Suji Fashions Ltd. Shyms Fashions Ltd.

(Present Location) Plot No.P-04, Mohora (Noxious) CDA Industrial Area, Chittagong.
(22.394087, 91.861443)
8th March 2017

Observations

Floor layout plan

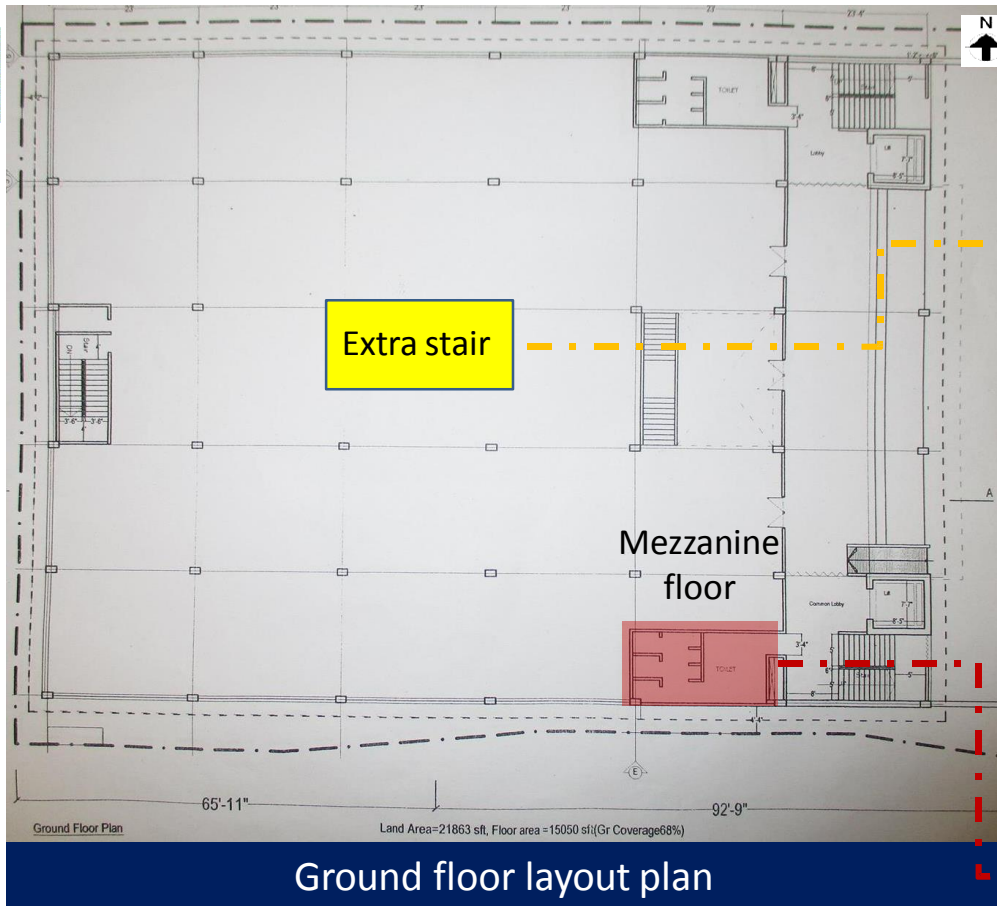
Discrepancies between provided drawings and as-built condition

Additional toilets with 200mm ~ 350mm floor built up on 2nd & 3rd floor

Full height brick walls on 1st floor

Internal partition wall of the factory building does not match with provided as-built drawings.

Ground floor layout plan

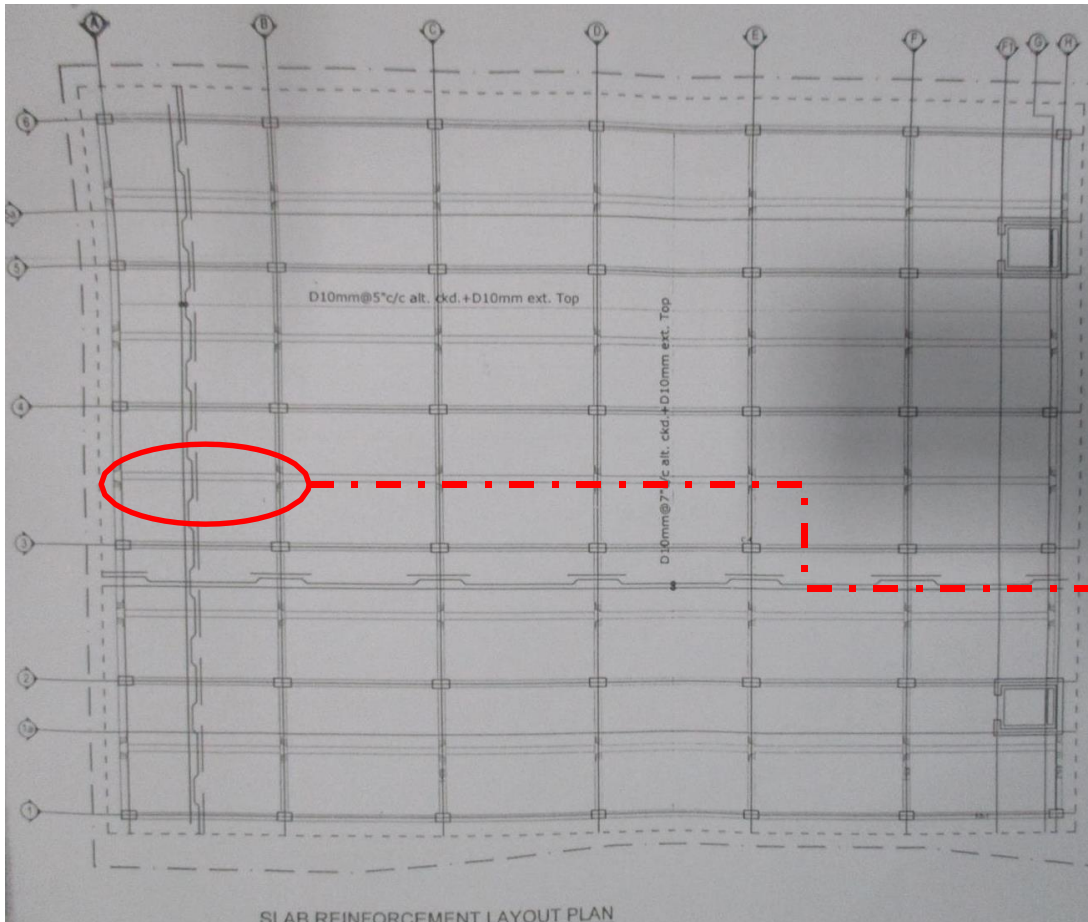
A undocumented mezzanine floor is found beside stair core at south east corner and a additional stair was observed at mid of the factory building which is in ground floor only.

The stair not shown in drawings.

Mezzanine floor not shown in drawings.

Beam layout plan

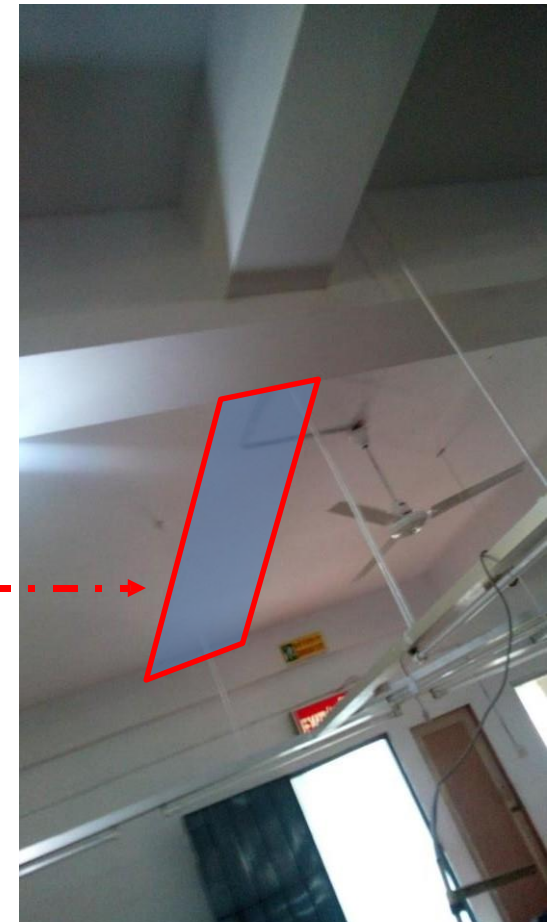
Beam missing on 2nd floor

A sub-beam is missing from at 2nd floor of factory building. Factory engineer to survey the whole structure and produce a set of as built drawings considering as-constructed condition.
